Public Works Department – Engineering Division

ADDENDUM NO. 4

PROJECT 5067 WTP FILTER IMPROVEMENTS AND HYPOCHLORITE CONVERSION

CONCRETE RETAINING WALL
DETAIL 10 VAR
NOT TO SCALE

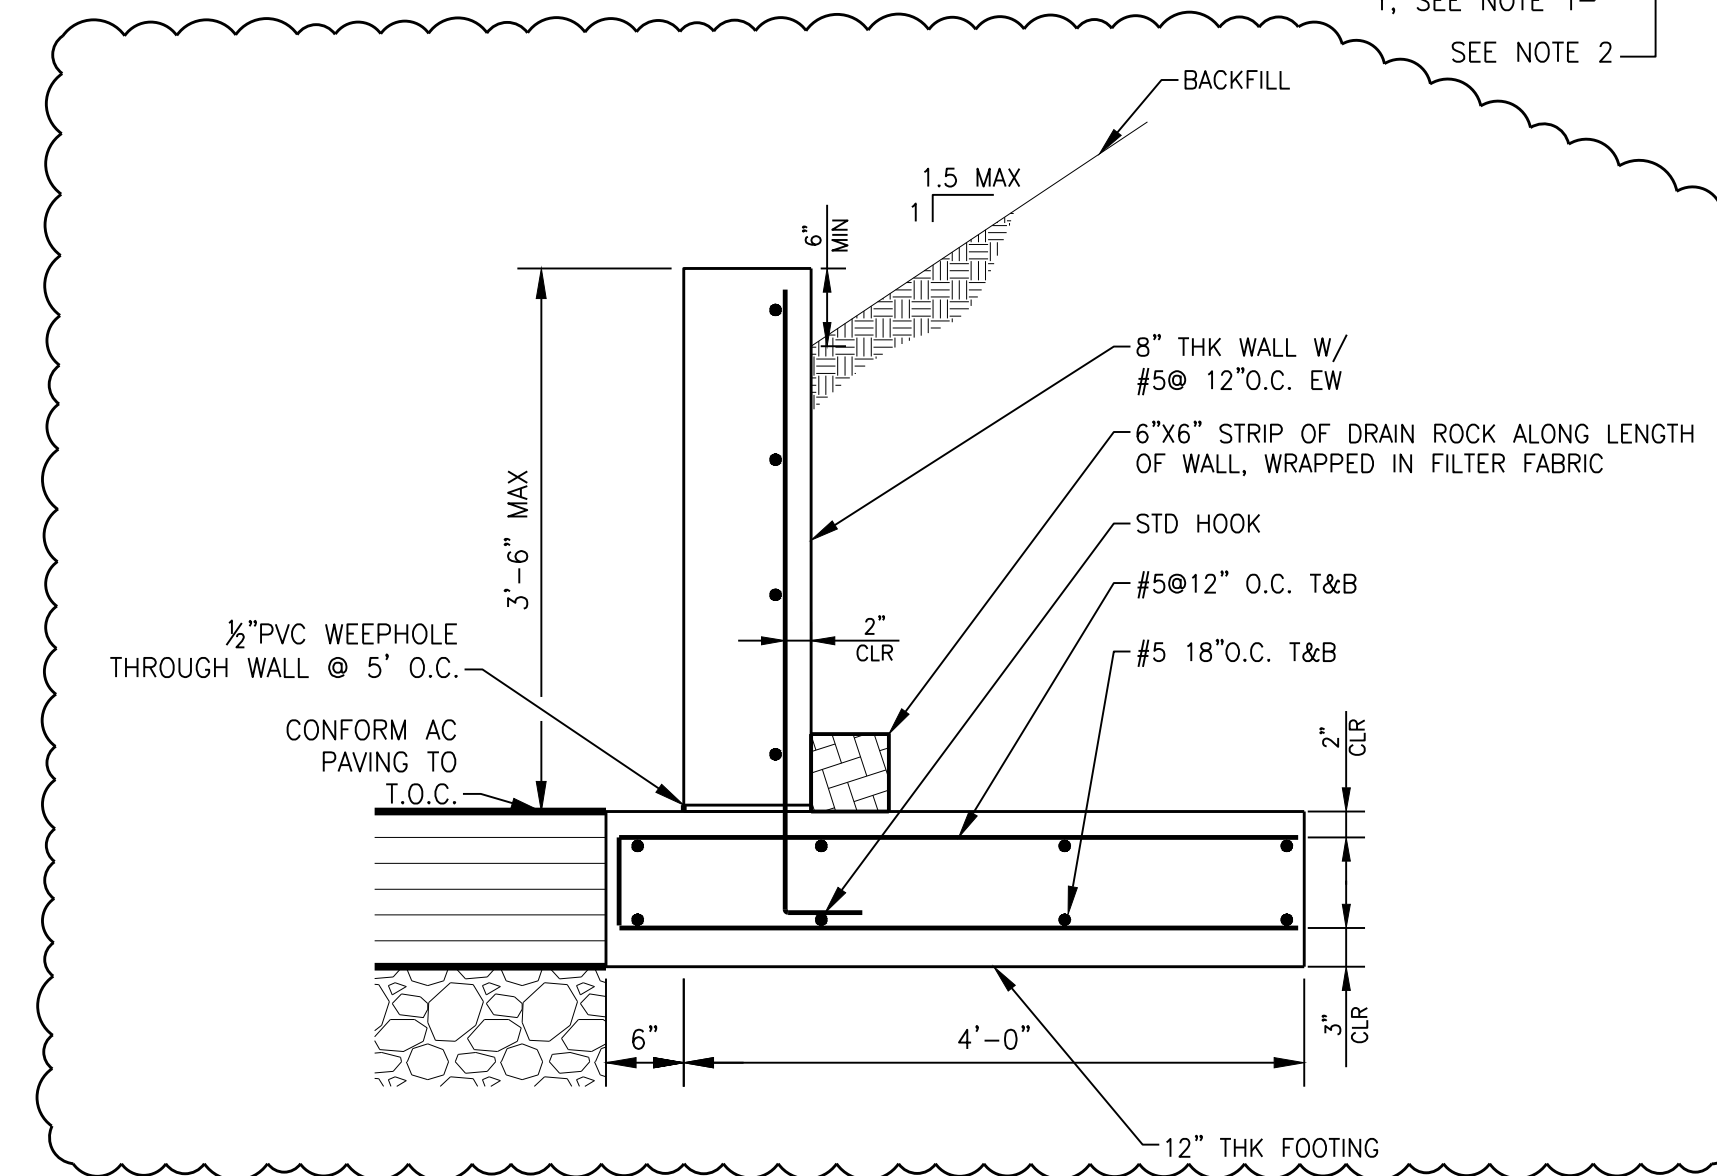
2. Replace Drawing GC001 with the attached updated Drawing GC001. Bidders shall note that the retaining wall detail that has been added to this drawing may be relocated to the Structural drawings as part of a design clarification developed following project award.

14. I would just like to try and get some clarification on this reclaimed brick wall on C203. I'm curious if you know that this will be a single or double brick wall, and what the footing for this is supposed to look like. Also, if there will be a cap.

Response: See Item A.42 in Addendum No. 3 for updated information about this wall. A detail for the replacement retaining wall is provided in this addendum, Item A.2.

**WATER TREATMENT PLANT
 FILTER IMPROVEMENTS AND
 HYPOCHLORITE CONVERSION**
 OVERALL WTP DEMOLITION PLAN

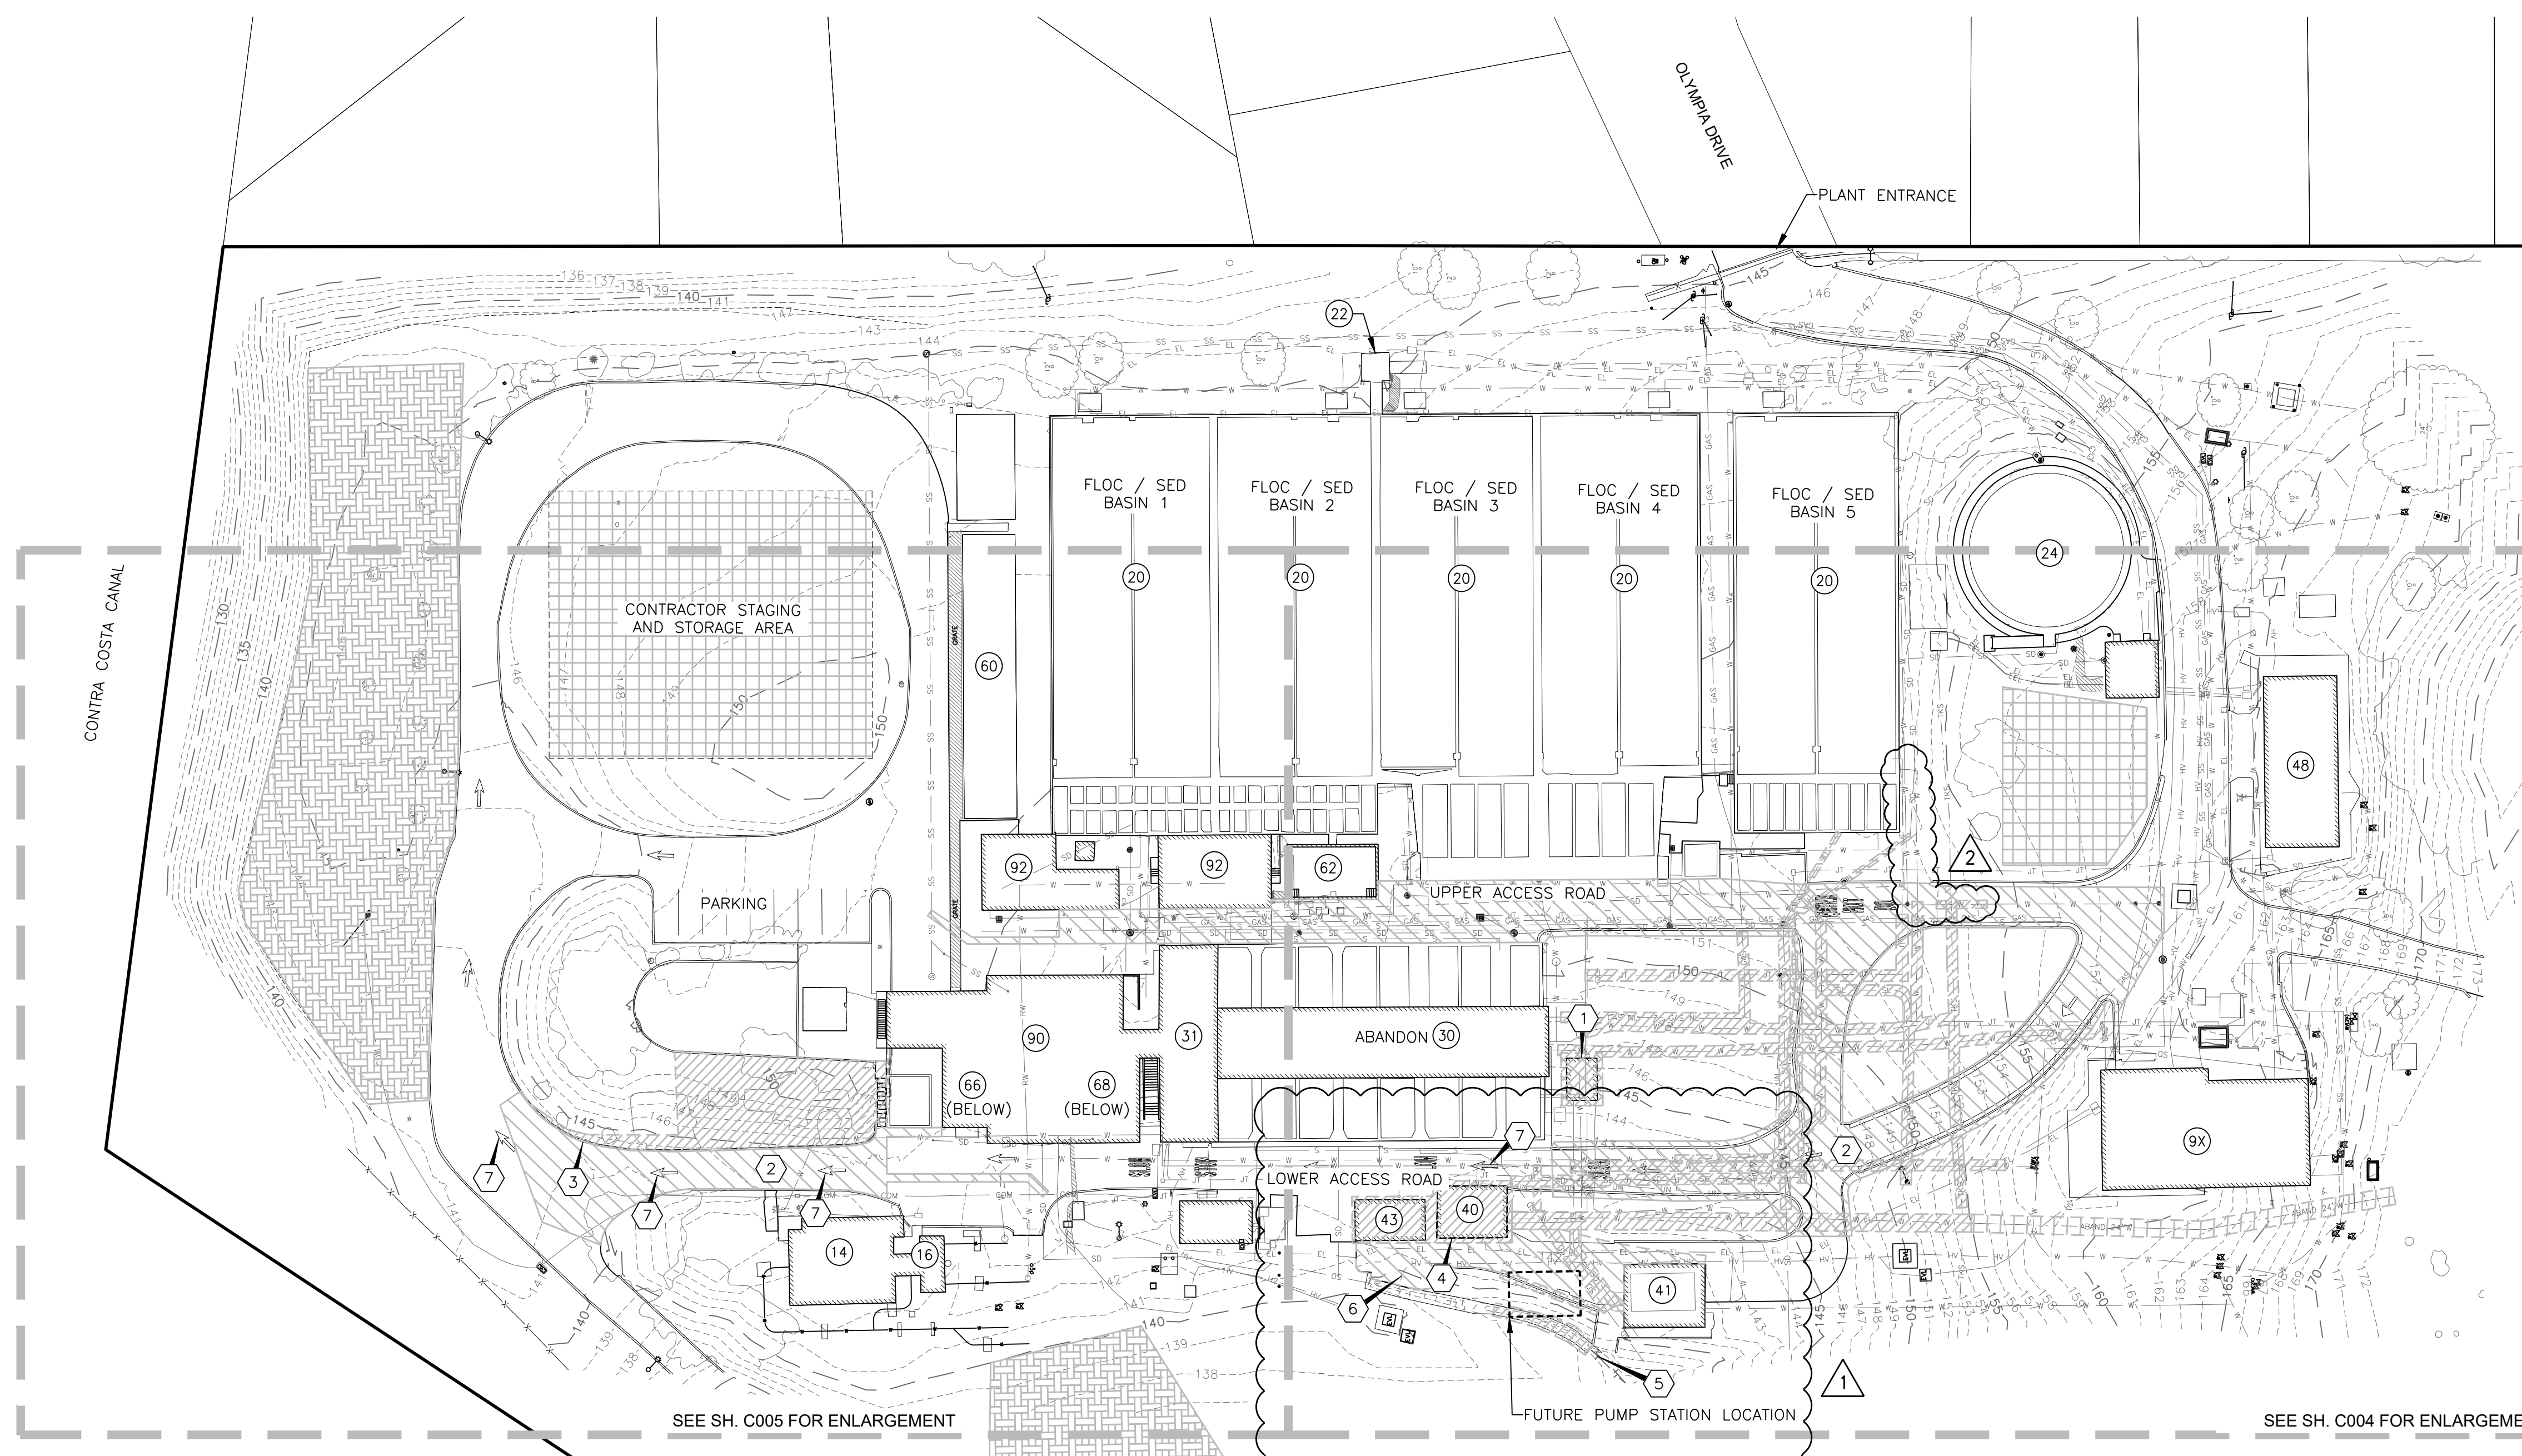
17. Provide a callout on sheet M302 for restrained flexible couplings on the CFE pipe exiting the filter gallery building.
18. Replace Drawing C003 with the attached updated drawing C003.

\\GNS-F501\Wainut_Creek\Clients\1040_City of Pittsburg\50-22-01_Filter & C12_Improvm\CAD\Production\1040-50-22-01-C004.dwg 4-02-24 11:01:52 AM akhon

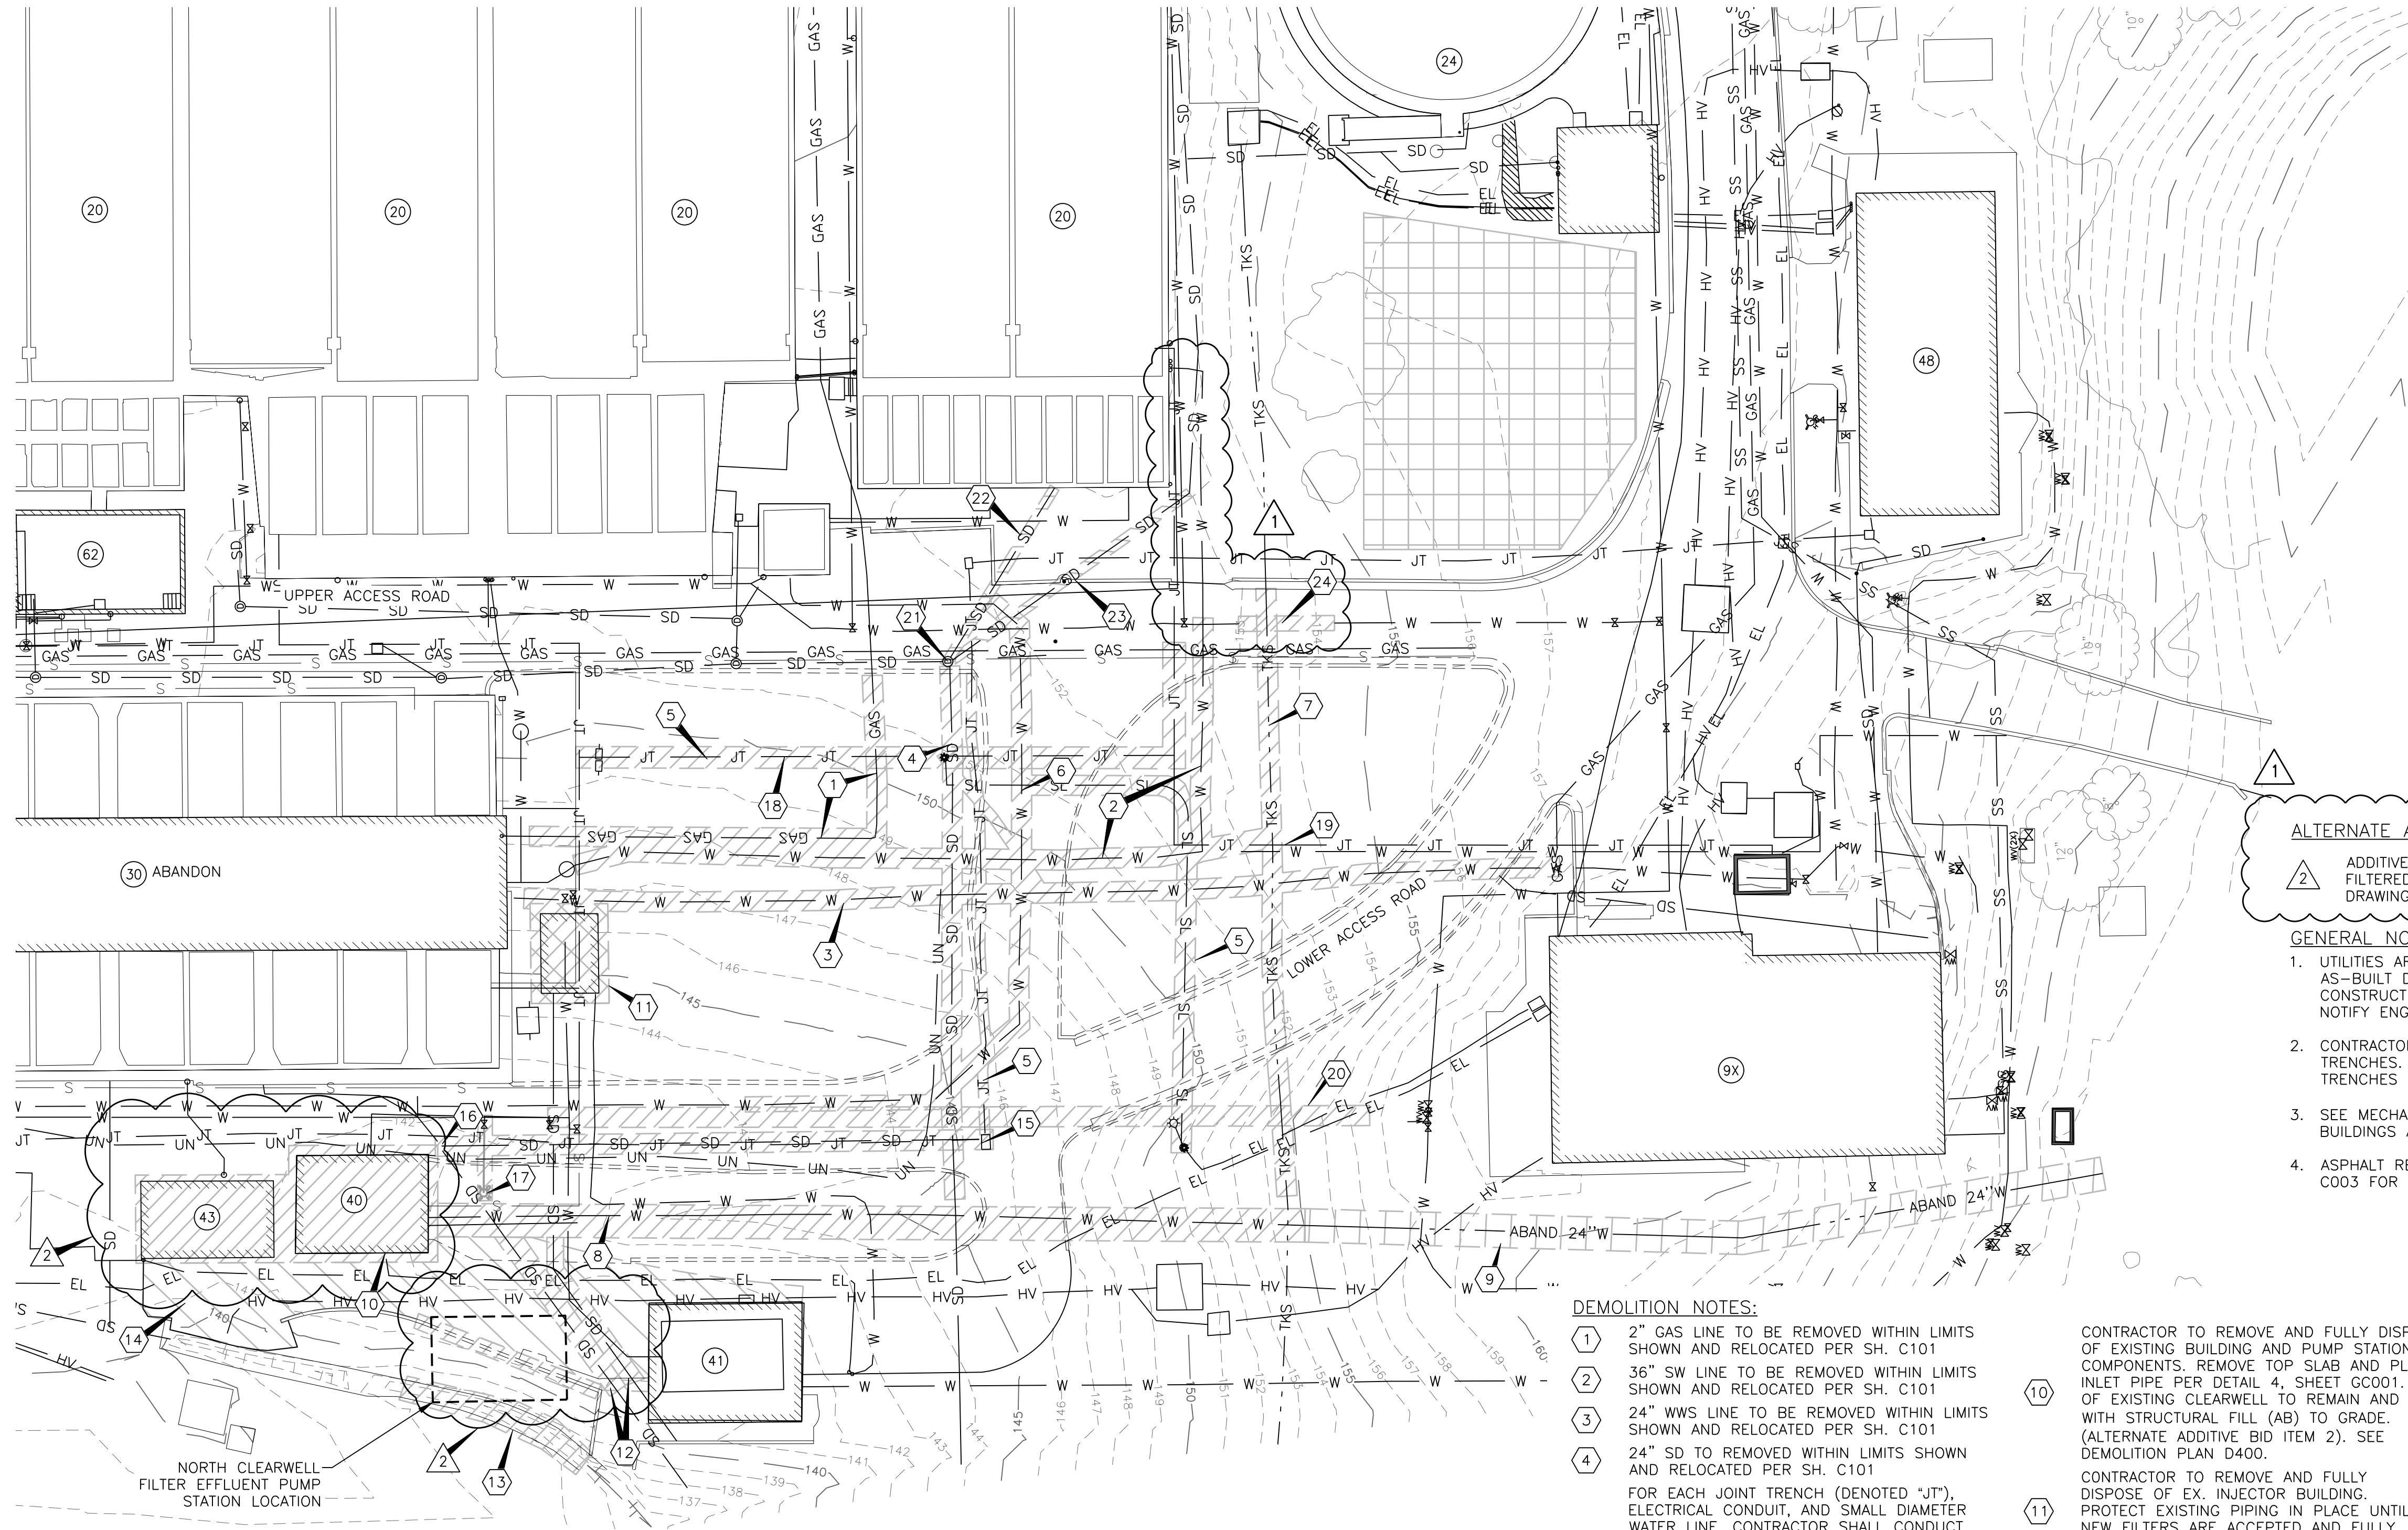
29. Note 5 on drawing C004 states, "For each Joint Trench (denoted JT), electrical conduit, and small diameter water line, Contractor shall conduct potholing and other field investigations to identify source and destination of fluid, power or signal. Contractor shall coordinate with Owner and Engineer on suitable demolition and relocation approach". In order for the Contractor to carry the proper cost in their Bid, please provide the size, pipe material and source/destination of all the Joint trench, electrical conduit, and small diameter water lines that will need to be relocated and demolished, or if quantities are unknown at this time, please consider making this an allowance bid item.
